RTP ENVIRONMENTAL ASSOCIATES INC.®

April 13, 1998

As discussed, I've enclosed copies of the materials from the recent Orimulsion hearings that relate to the calculation of historical NO_x emissions. These include excerpts from the January hearing testimony, rebuttal, and surrebuttal, as well as recommended changes to the Conditions of Certification.

We still believe that the historical NO_x calculations have been done incorrectly and that the subsequent back-up by the applicant, submitted to the agency on January 22nd and 23rd and provided to us on April 3, 1998 is deficient. We responded to this issue separately in an April 8, 1998 letter, which is also enclosed. Additionally, it is my understanding that Administrator Hankinson was sent a full copy of our overall comments by Thomas W. Reese, Esq. on March 30, 1998.

Manatee Plant Unit 1 NOx Data
July 1996 to July 1997

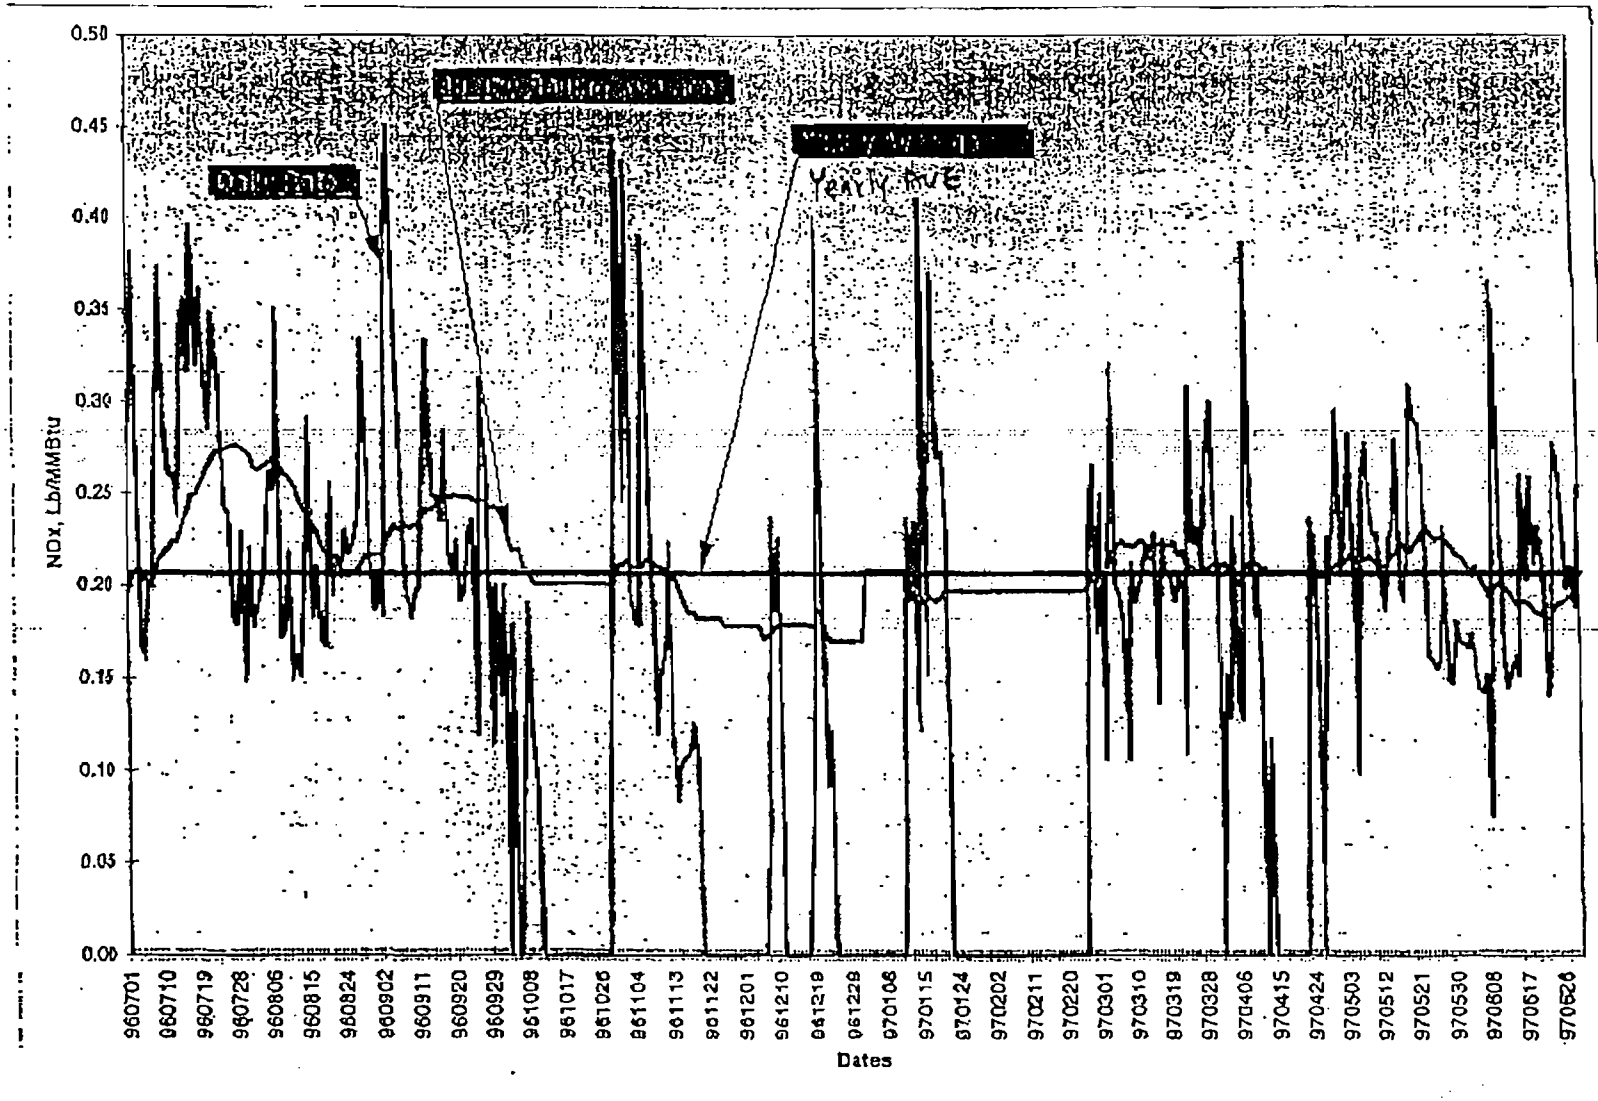
17 A Mr. Elias's calculation incorrectly
18 considered what's called net load in his calculation,
19 that is the actual load while the plant is operating.
20 He did conclude that it was appropriate that NOx
21 emissions go up with load, but did not take that into
22 consideration in this calculation. If he did, he would
23 get a totally different conclusion than as shown on
24 this exhibit.

4 I have listed in two columns the 1993, '94,
5 and 1995 net load factors. For '93, '94, it was 56
6 percent and for '95, '96, it was 41.1 percent. This is
7 a significant difference in how the plant operated
8 during those time frames.

12 A I looked at the 1995, 1996, CEM data and the
13 corresponding load data, developed a relationship of
14 NOx emissions with load, then used that relationship to
15 estimate 1993, '94, NOx emissions based on the actual
16 load that the plant was operating in those years.

BEST AVAILABLE COPY
Manatee Plant Unit 1 NOx Data
July 1996 to July 1997

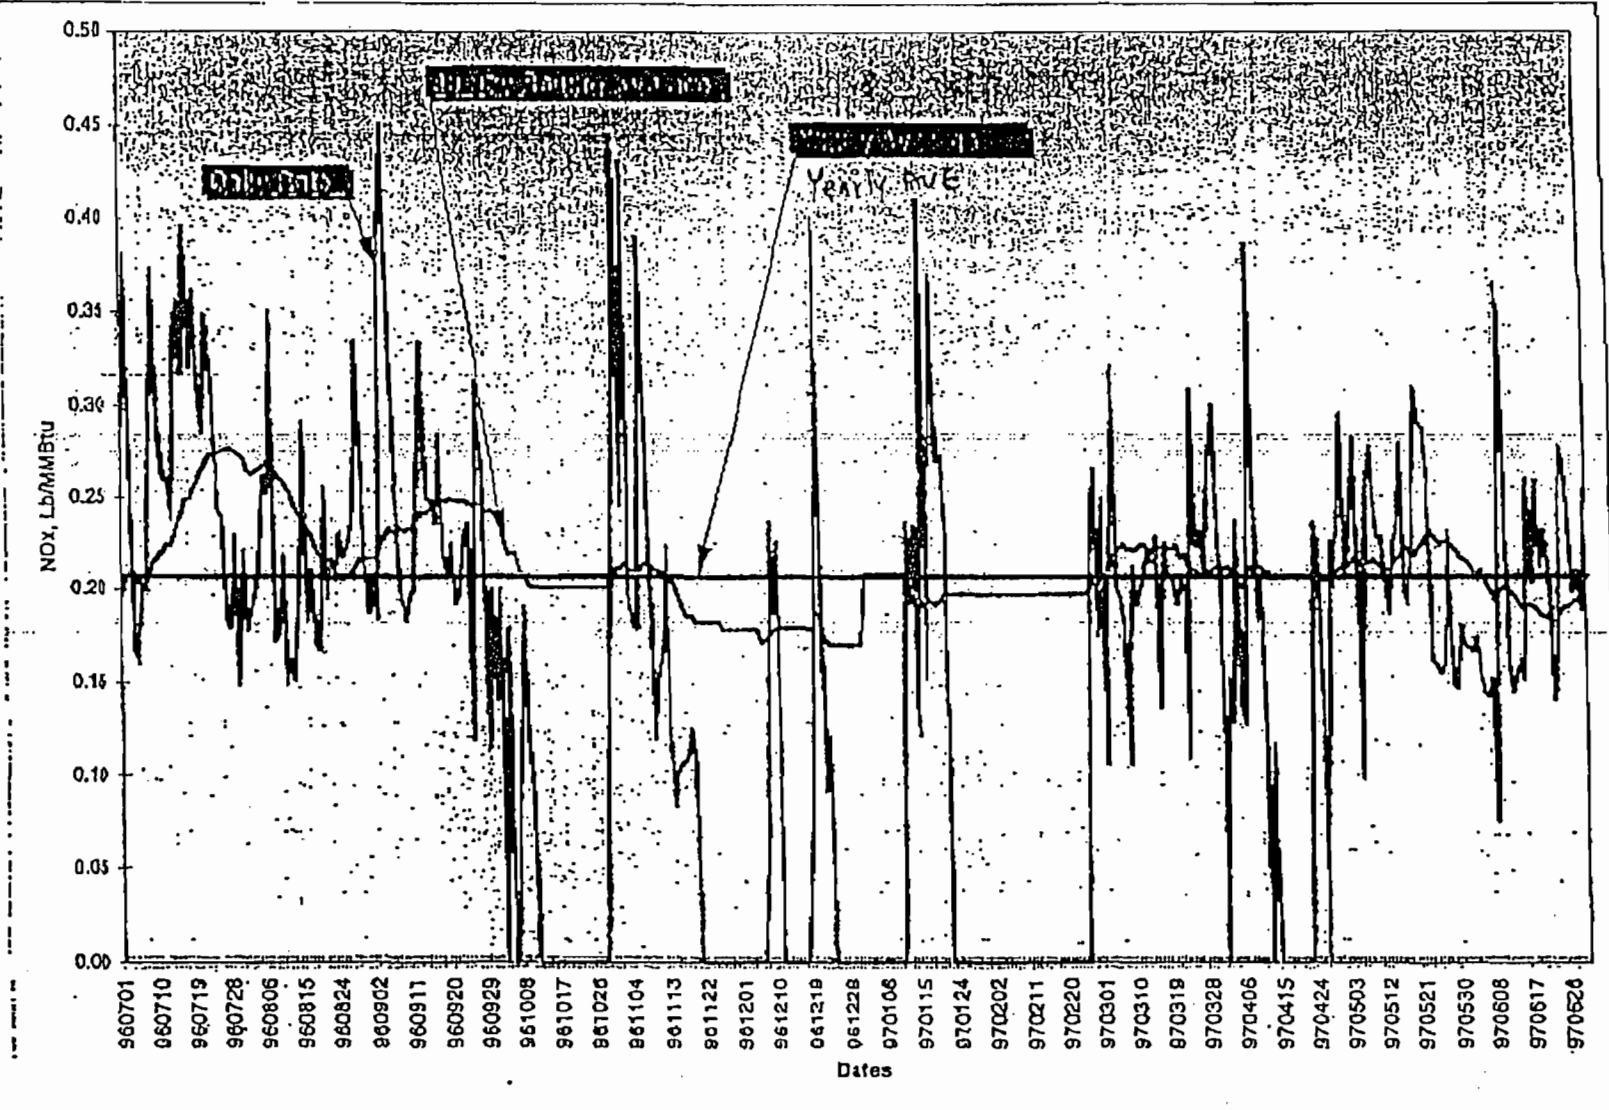
$$\text{NOx} = 0.53 (\text{NLF}) - 0.00282$$

NLF	NOx (lb/mmBtu)
1993 Unit 1	55.03%	0.294 .289
1994 Unit 1	51.01%	0.273 .267
1993 Unit 2	59.54%	0.318 .313
1994 Unit 2	58.51%	0.313 .307
Average:		0.300 .294
